List of Changes From the City Council-approved (June 10, 2024) Ongoing Parklet Regulations (revision #3 – dated November 19, 2025)

PALO ALTO ONGOING PARKLETS PROGRAM

(Adopted June 10, 2024; Last Revised February 4, 2025)

FIGURE 4: Platform Attachment Detail

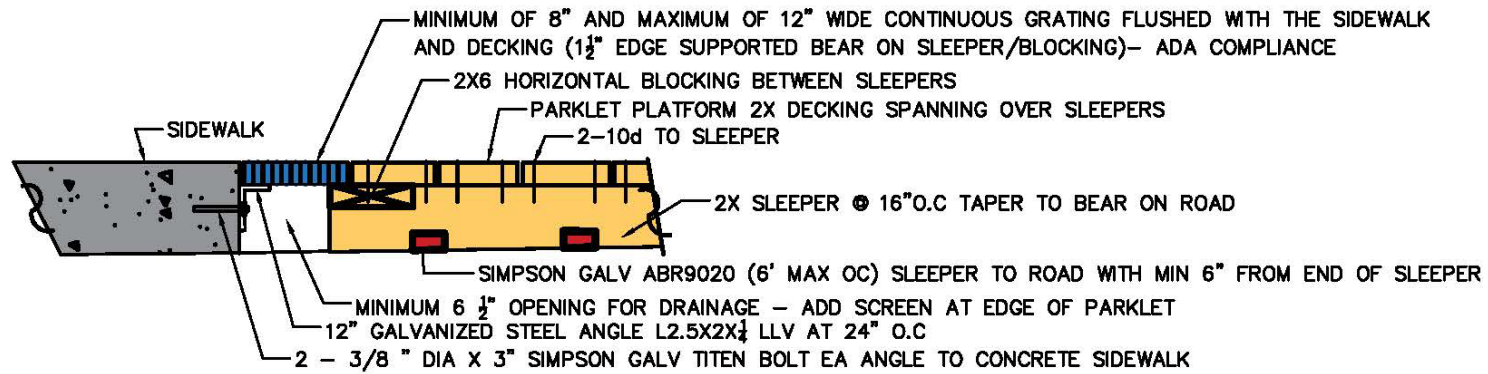
- **Platform Anchoring:** A change clarifying the maximum anchoring embedment is 6-inches.
- **Platform Slope for Drainage:** It is now required that if the parklet is uncovered, the parklet floor shall be sloped a minimum 1/8 inch / linear foot and a maximum ¼ inch / linear foot towards the sidewalk. The closure decking shall be removable for easy access for underplatform inspection as needed. See Figure 4 for suggested platform attachment design details. (Section IV. A. 2. e.)

- b. Adequate cross ventilation shall be installed to allow for the surface to dry within 24 hours.
- c. Parklets shall not impede the flow of curbside drainage. The parklet design shall include a minimum 6.5-inch-wide clearance from sidewalk curb along the entire length of the parklet. An ADA-compliant continuous grating flushed with the sidewalk and decking shall cover the clearance between the sidewalk curb and the parklet floor. See Figure 4 for detailed requirements.

- e. If the parklet is uncovered, the parklet floor shall be sloped a minimum 1/8 inch / linear foot and a maximum ¼ inch / linear foot towards the sidewalk. The closure decking shall be removable for easy access for underplatform inspection as needed. See Figure 4 for suggested platform attachment design details
